**RE:** **ABP REF:** ABP-300559-18  
**DCC REF:** SHD0003/17  
**Location:** Lands east of St. Paul's College, Sybil Hill Road, Dublin 5

## **Chief Executive's Report**

**Response to An Bord Pleanála in accordance with the requirements of Section 8(5)(a)  
of the Planning and Development (Housing) and Residential Tenancies Act 2016**

**ABP Case No: 300559 St Pauls College, Raheny. Applicant: Crekav Trading Ltd**  
**Comments to ABP by DCC Parks & Landscape Services**

- Applicant's Proposed Master Landscape Plan

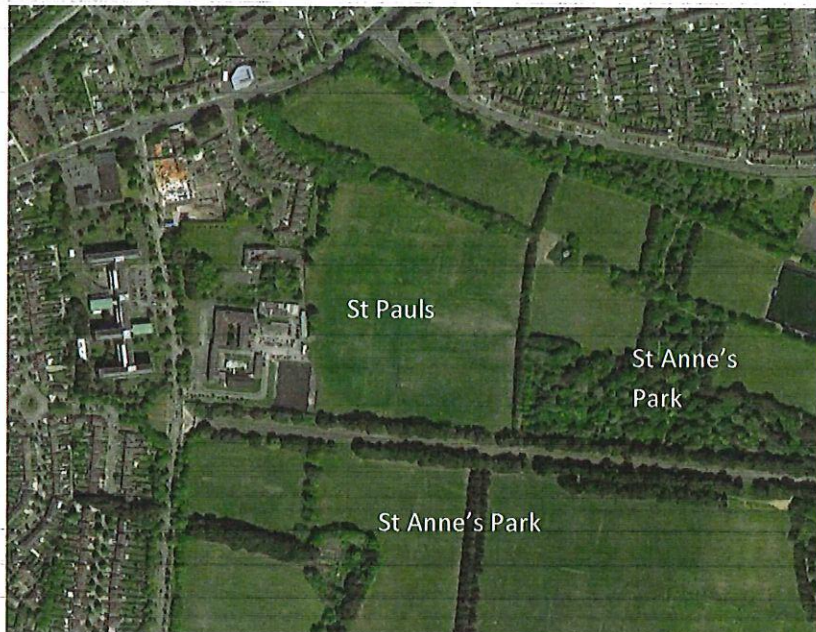
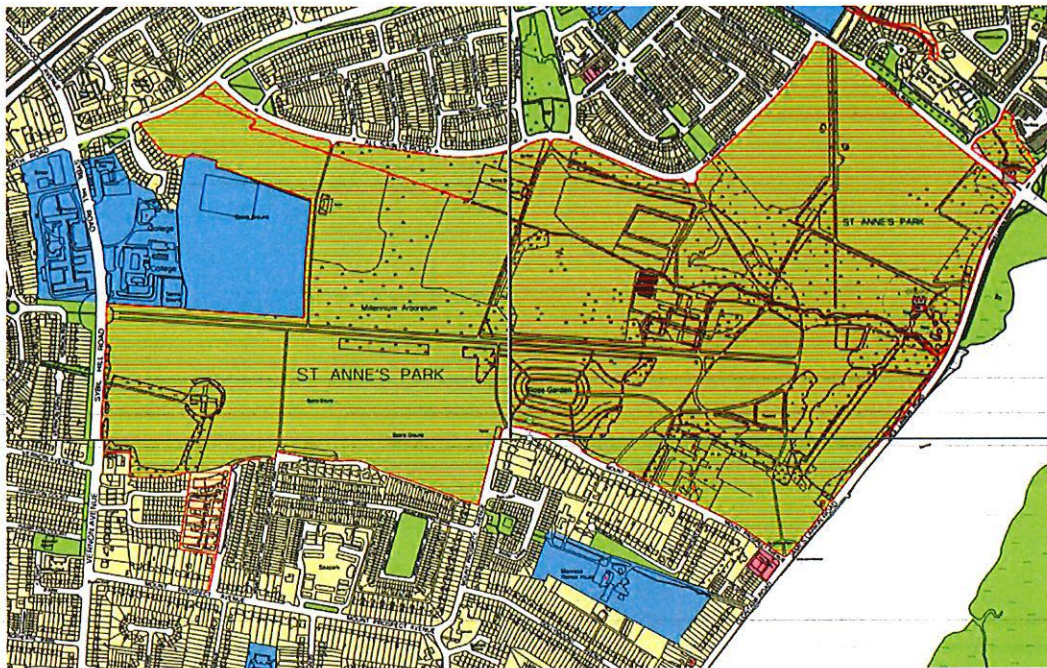
The application proposes the residential development of St Paul's school grounds and in particular the playing fields to the rear of the school which lie adjacent to St Anne's Park. St Anne's Park is a Flagship Park, Zoned Z9 with the Specific Objective of a Conservation Area in the Dublin City Development Plan. The application site was originally part of the St Anne's estate. The site is zoned Z15 Institutional & Community with the objective: To protect and provide for institutional and community uses and to ensure that existing amenities are protected.

#### 4.3 Drainage outfall to the Naniken River

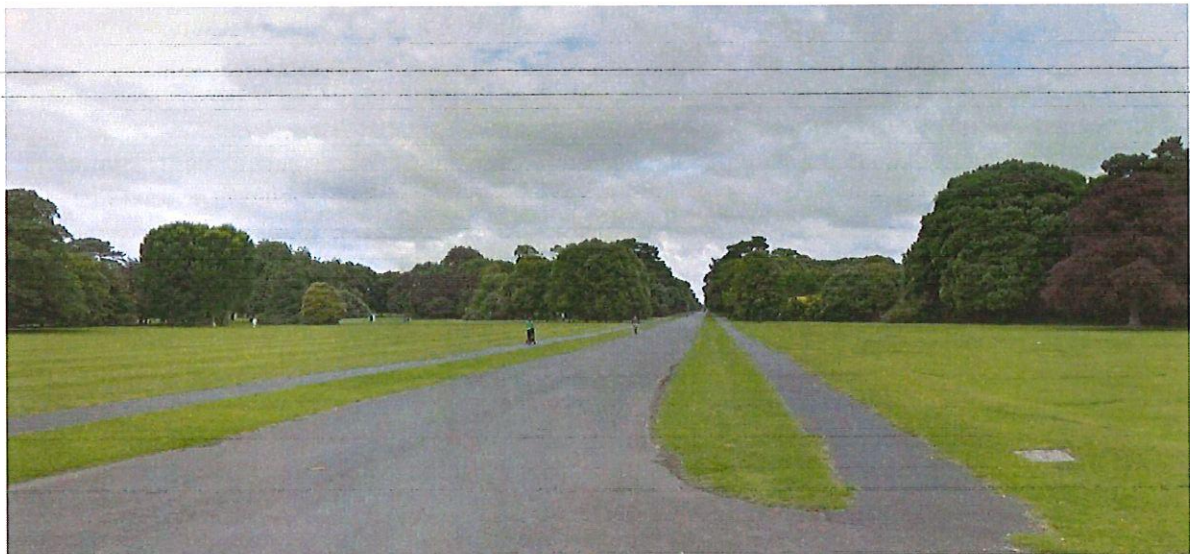
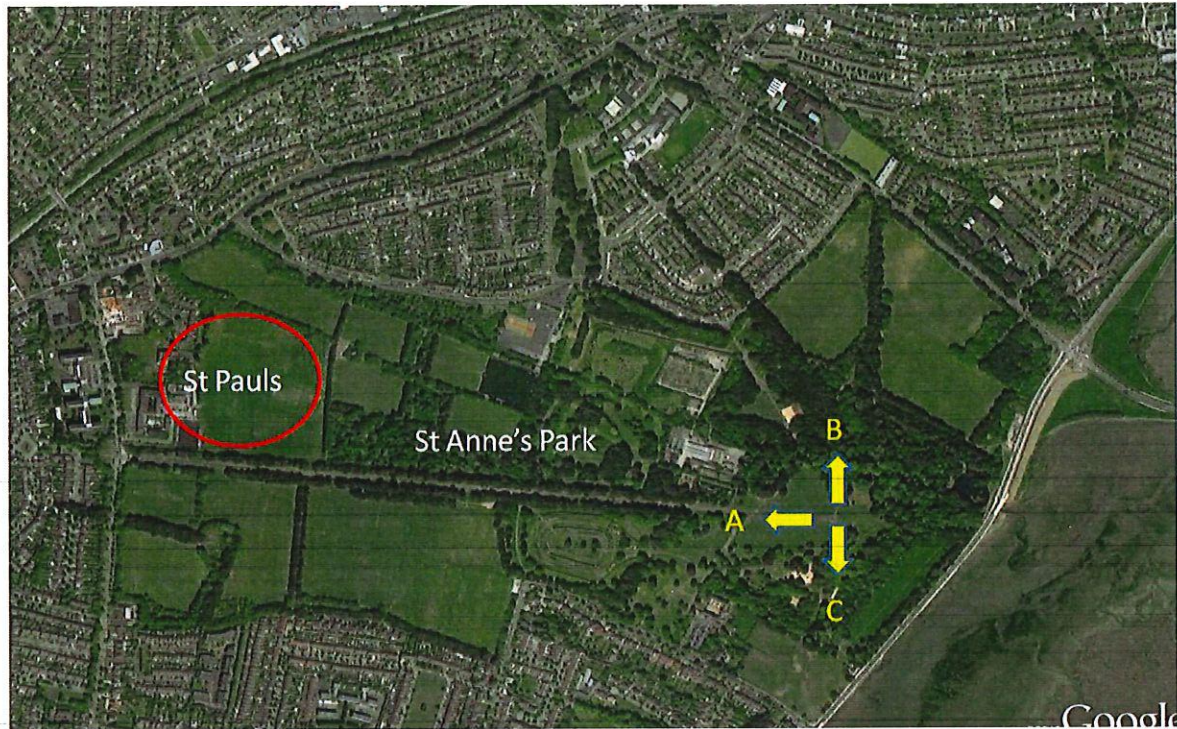
This issue has been discussed following the ABP pre-application meeting. A satisfactory alignment of the proposed drainage pipe has been achieved. The implementation will require approval of details of construction and finish.

Development shall not commence until the finalised alignment and details of the surface water pipe are agreed in writing with the Planning Authority. The design and construction of the pipe will minimise impact on existing tree root zones and will include on-site supervision by a qualified Arboriculturist employed by the developer and reporting to the Planning Authority. Following construction the alignment will be landscaped in accordance with the approved landscape scheme.

Development shall not commence until requirements for demolition and reconstruction of the bridge with proposed drainage pipe outfall at the Naniken River are agreed with the Planning Authority. During the works a temporary river crossing bridge and temporary link paths, will be installed and maintained by the developer. The design of the reconstructed bridge will be of a traditional estate bridge style, including stone facing, surfacing and ironwork railings to the approval of the Planning Authority. The reconstructed bridge will be subject to an 18 month defects liability period.
